CITY OF ALBUQUERQUE

**RE: Smith's #423 Fuel Center
5640 4th St NW
Grading and Drainage Plan
Engineers Stamp Date 1/26/16 (F14D072)**

Abiel Carrillo, P.E.
Principal Engineer, Hydrology
Planning Department

Grading Plan
Smith's #423 Fuel Center
5640 4th Street N.W.
Albuquerque, New Mexico 87107

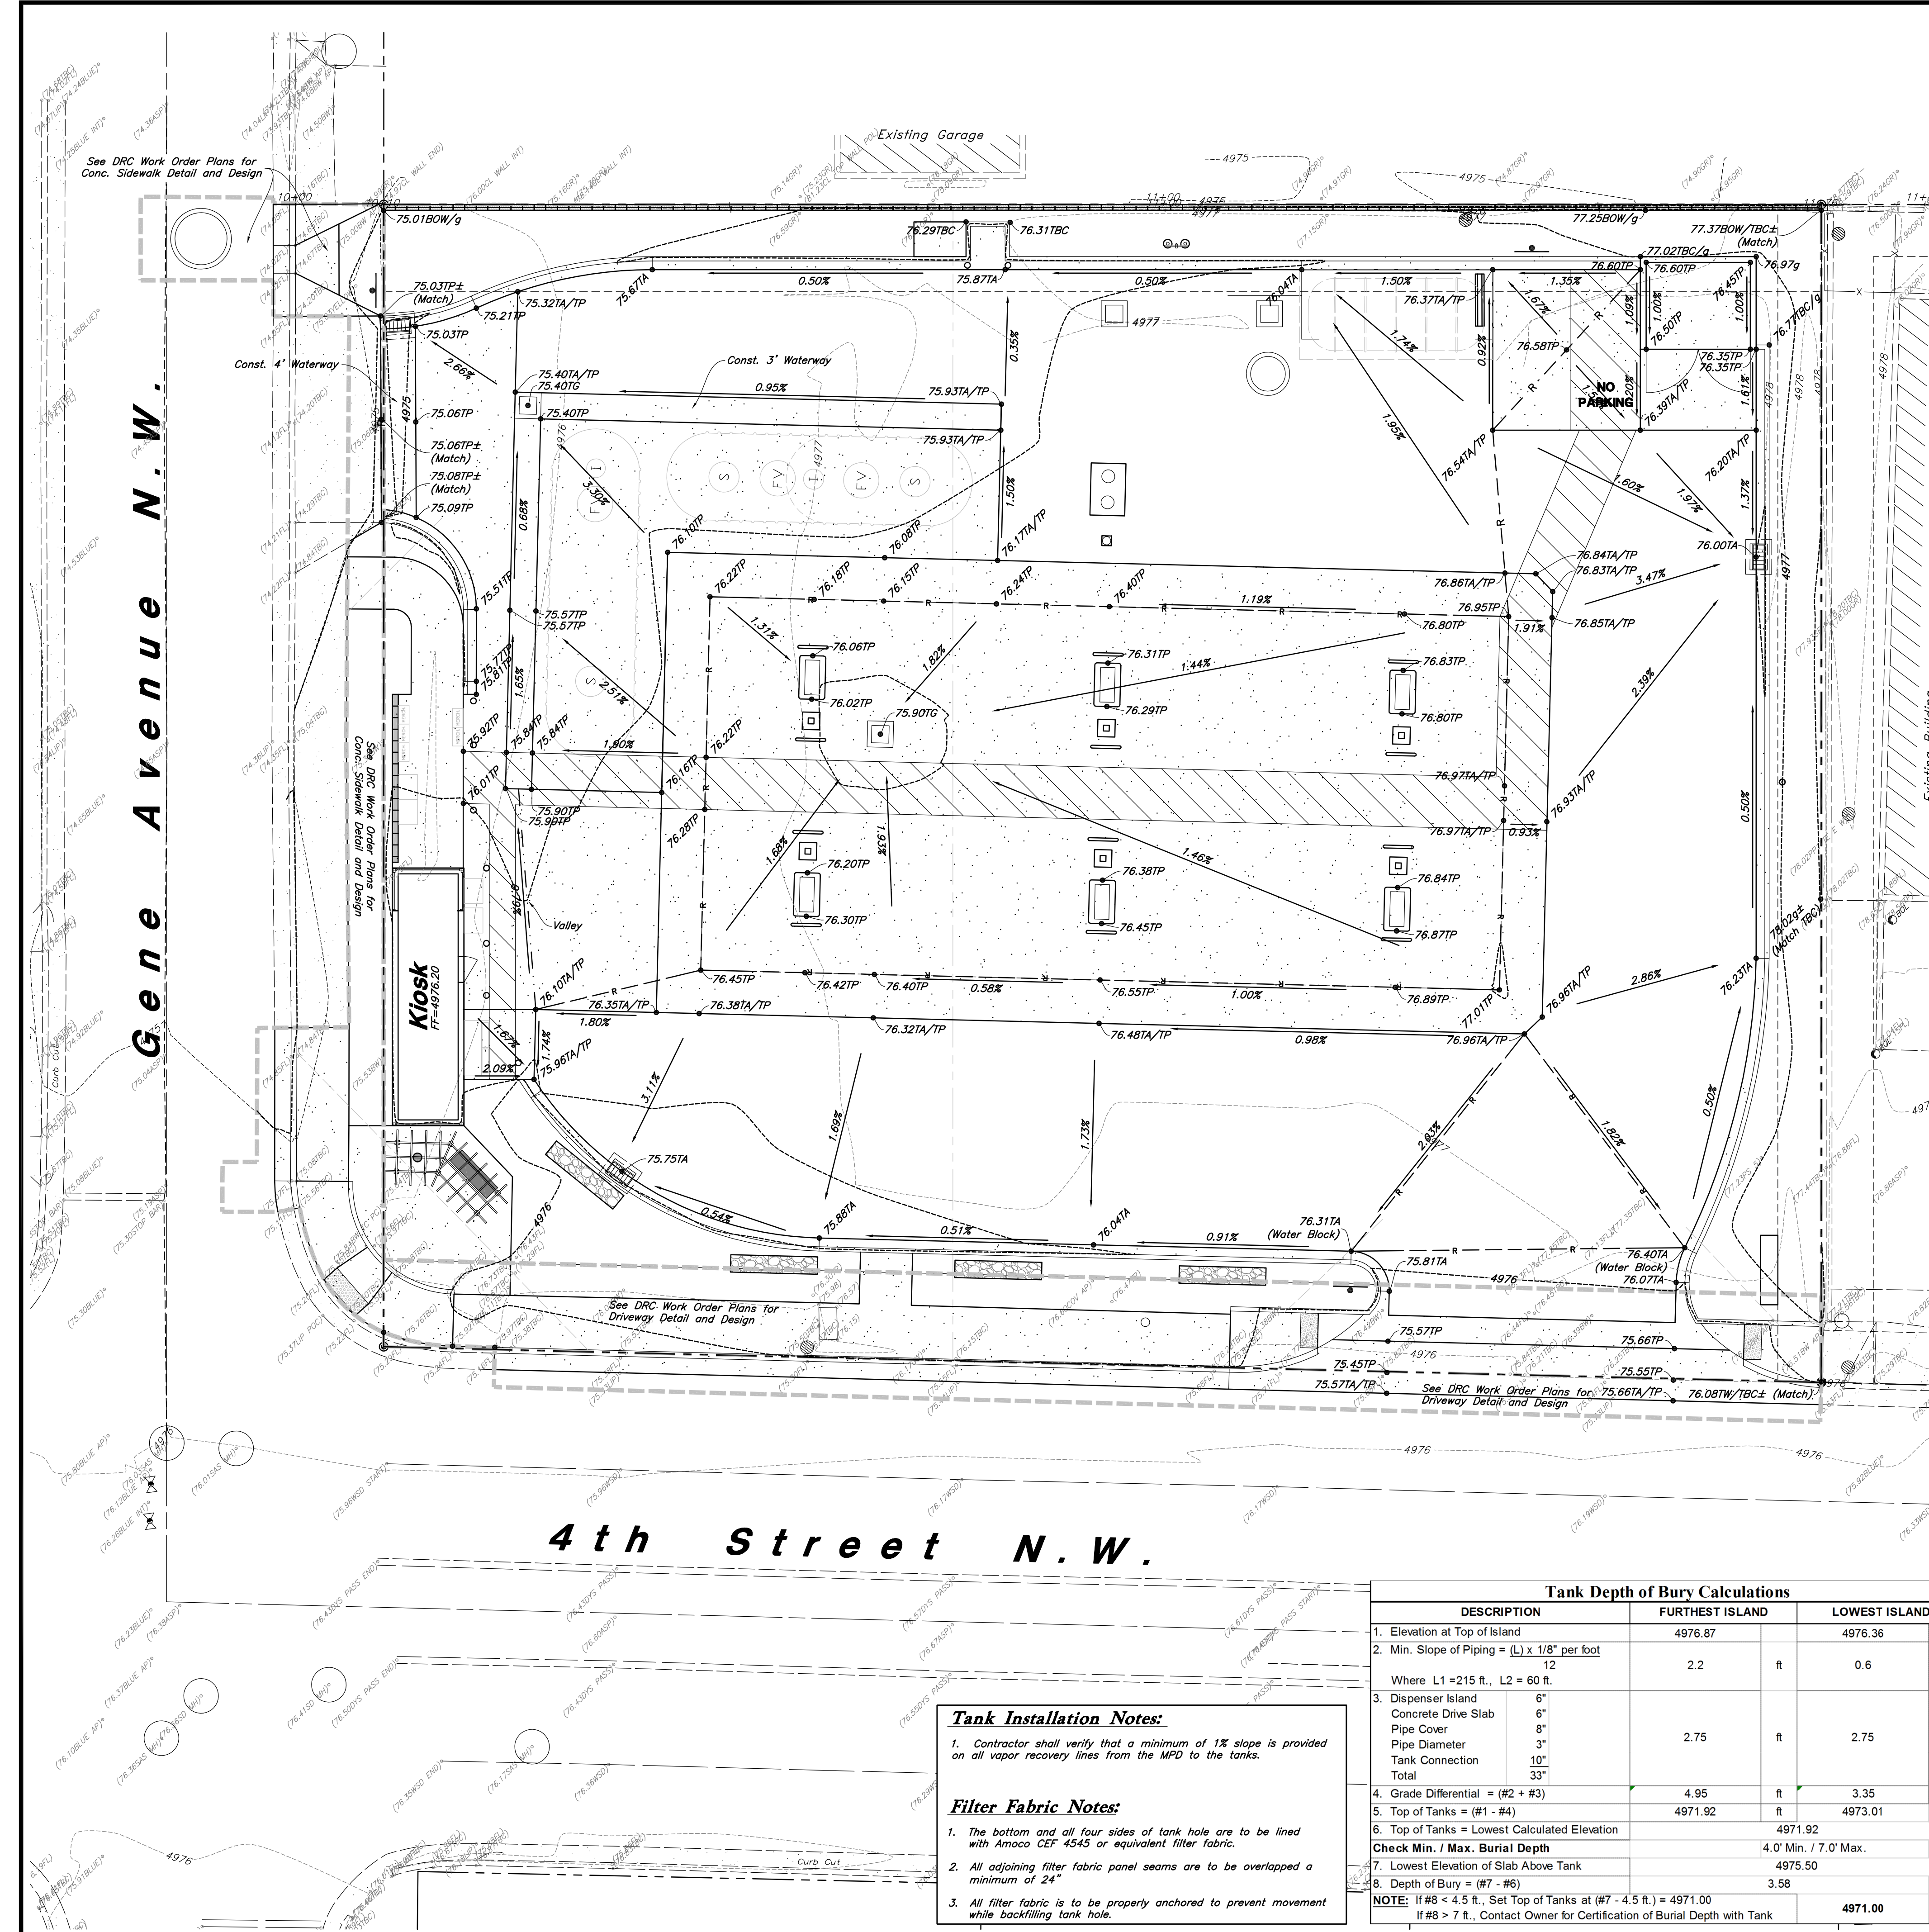
Based upon the information provided in your submittal received 1/27/16, this plan is approved for Grading Permit, Paving Permit and Building Permit. However, before construction may begin the DRC must approve the plan set.

Please inform the Architect/Owner or the contractor to attach a copy of this approved plan dated 1/26/16 to the construction sets in the permitting process prior to sign-off by Hydrology. If this plan is not with the construction plan sets the permitting process will be held up until the plan is provided.

Prior to Certificate of Occupancy release, Engineer Certification per the DPM checklist will be required.
